Hi-Fi Products  
**Service Bulletin**

**Model:** CDP35,40,55,65,203

**No. 8**

**Subject:** Intermittent No Eject

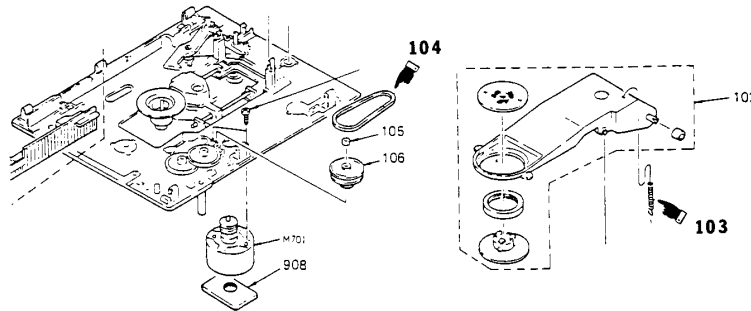
**Symptom:**  
(65)  
Intermittent no eject.

Please note that on CDP35 and 40, the LM belt has a number reference of 105 instead of 104 as is shown below.

Replace the LM belt and the tension spring with the new parts listed.

Ref. Number	Description	Part Number	
		Former	New
103	Tension Spring	4-913-792-01	4-913-796-01
104	LM Belt	3-653-387-00	4-913-797-01
